Product Discontinuation Notices

No. 2011101E

Discontinuation Notice of UV-Light Curing Systems. ZUV-H[]M series

Characteristics

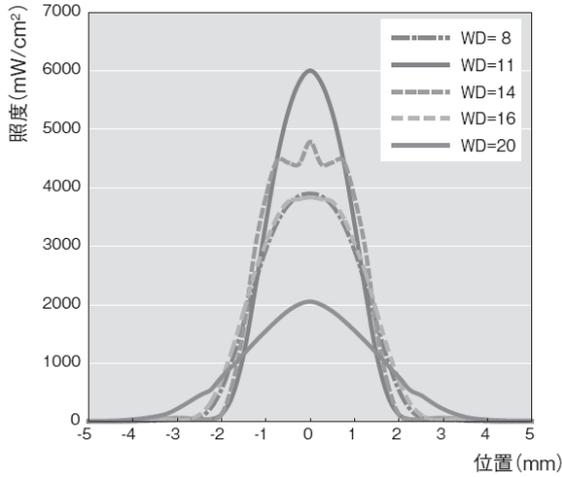
Product discontinuation	Recommendable replacement
<p>There are parts that the material changed from copper to zinc.</p> <p>Model ZUV-H10M Material :Aluminum, glass, copper</p> <p>Model ZUV-H30M/Model ZUV-H35M Material :Aluminum, glass, copper</p> <p>Model ZUV-H30M-1 Material :Aluminum, glass, copper Weight (in packing) : Approx 150g (Main unit: approx. 55g)</p>	<p>Model ZUV-H10MB Material :Aluminum, glass, copper, zinc</p> <p>Model ZUV-H30MB/Model ZUV-H35MB Material :Aluminum, glass, copper, zinc</p> <p>Model ZUV-H21MB Material :Aluminum, glass, zinc Weight (in packing): Approx 185g (Main unit: approx. 100g)</p>

Operation ratings

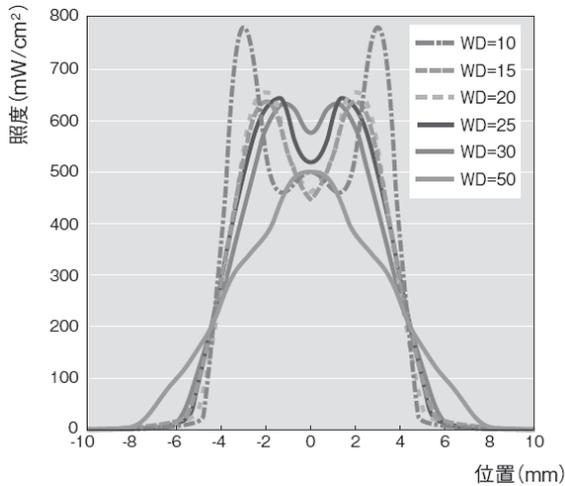
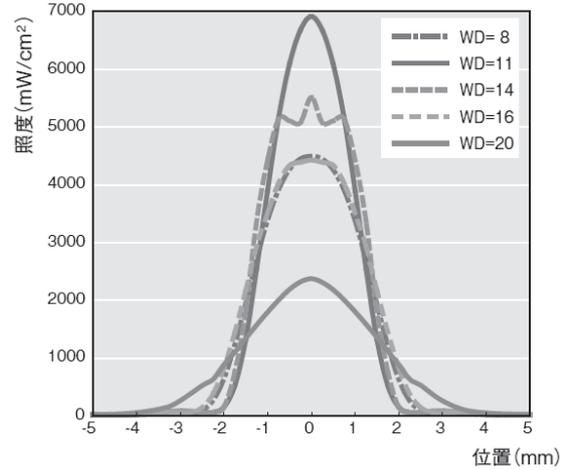
The luminance increases by a factor of about 1.15.

Model ZUV-H[]0M
When lens unit ZUV-L3H is mounted.
(One example of lens)

Model ZUV-H[]5M
When lens unit ZUV-L12H is mounted.

Model ZUV-H[]0MB
When lens unit ZUV-L3H is mounted.
(One example of lens)

Model ZUV-H[]5MB
When lens unit ZUV-L12H is mounted.
